Critique of “The Future of the Nuclear Fuel Cycle: An Interdisciplinary MIT Study (2011)”

Developed by the Science Council for Global Initiative
Contact: Tom Blee <tomsciencecouncil@gmail.com>

Figure 1. Radiological toxicity of LWR spent fuel constituents as a function of time

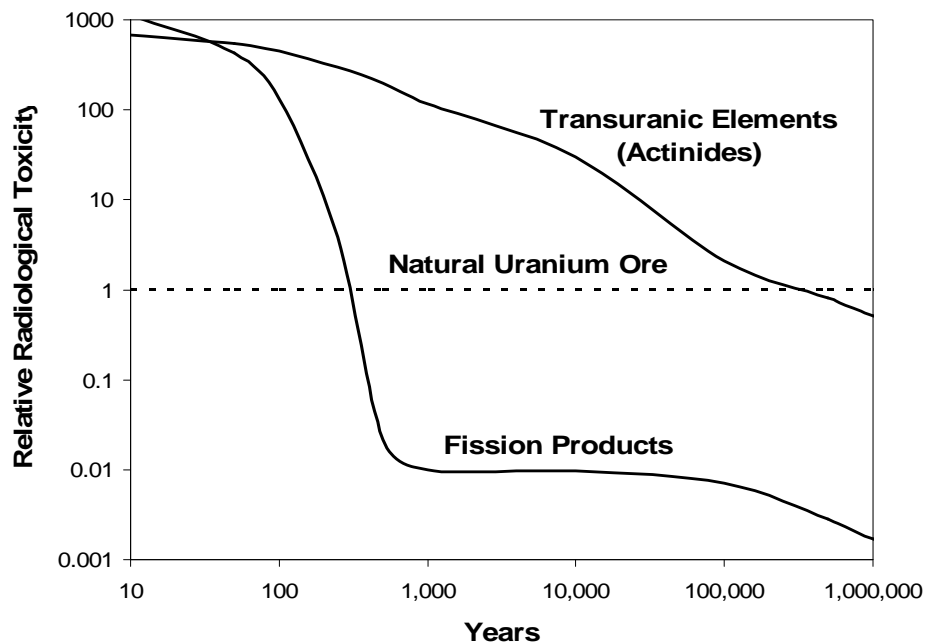
For all practical purposes, the radiological toxicity due to the fission product portion of the waste decays with (approximately) a 30 year half-life, due to the dominance of strontium and cesium isotopes. It drops below the natural uranium ore level in about 300 years, and becomes harmless in well under 1,000 years. On the other hand, the radiotoxicity level associated with the actinide portion stays far above that of natural uranium ore for a very long time, and remains at least three orders of magnitude higher than that for the fission products for hundreds of thousands of years. This is why following the National Academy of Sciences Committee recommendation, the EPA standards and NRC regulations for the Yucca Mountain repository extended the regulatory timeframe from the original 10,000 years to one million years.

The important point is this: if 99.9% of actinides could be removed from the waste form, then the radiological toxicity of the remaining 0.1% actinides would stay below the level of natural uranium ore at all times and the effective lifetime of the waste would be dictated by the fission products. If the actinides were mostly removed from the waste stream, the EPA standards and the NRC regulations [whether they cover 10,000 years or millions of years] can be met on an *a priori* basis.

Needless to say, this is an extraordinarily important fact, and the MIT Study ignored it.

Figure 2. Specific Inventory vs. Reactor Size (MWe) Figure 3. Range of Breeding Ratios

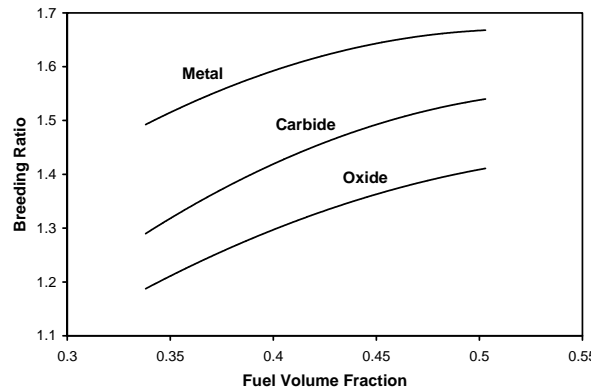
- The analysis used ALMR (PRISM Mod B) as the representative fast breeder reactor design, with a specific inventory (kg fissile material per megawatt electric) about a factor of two too high. The specific actinide inventory is presented here in Figure 2 as a function of the reactor size.

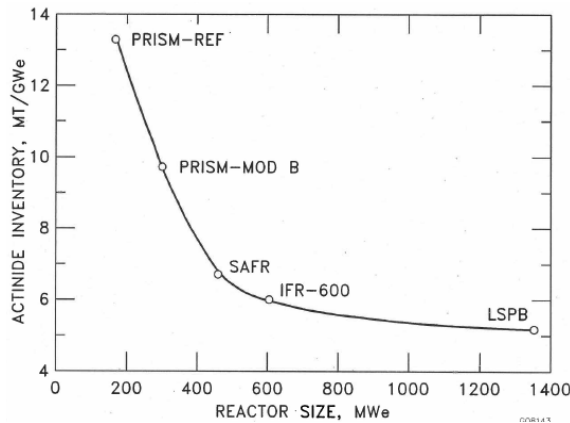
- A breeding gain of 0.23 was assumed, which is too low by a factor of two or three. The breeding ratio potential for what we'll call "advanced" fast reactors is presented in Figure 3 for various fuel types. Here, breeding ratio is the net gain in fissile material over some period of time, compared to the fissile loss from power generation. The metal fuel developed during the Integral Fast Reactor (IFR) program has become the reference fuel in the U.S. It has a breeding ratio potential in the range of 1.50–1.65. In the early years of deployment, the high breeding gain is not needed, but it is there from the start, and it can be used by simply deploying more U^{238} "blankets"—reflector regions actually—to capture a higher fraction of the neutrons leaving the core. If you don't need the plutonium early in fast reactor deployment, you would not load full blankets. A key advantage of the fast reactor design is that the plutonium production rate can be easily tailored to plutonium demand.

Figure 4. Example scenario for worldwide nuclear energy growth

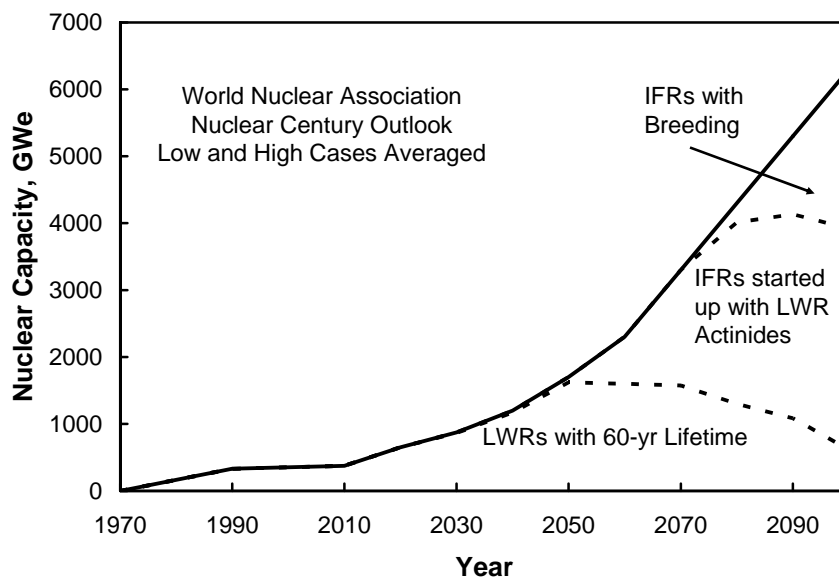
An example of nuclear fuel cycle system analysis more properly done is illustrated in Figures 4 and 5. These figures depict a scenario for world-wide nuclear energy growth, and the impact of fast reactors on the cumulative uranium requirement is very clear. The introduction of breeders can cap the LWR capacity (Figure 4) and hence also cap the ultimate uranium requirements (Figure 5). The divergence of the cumulative uranium requirements (Figure 5) will continue to widen if the plot is extended beyond 2100.
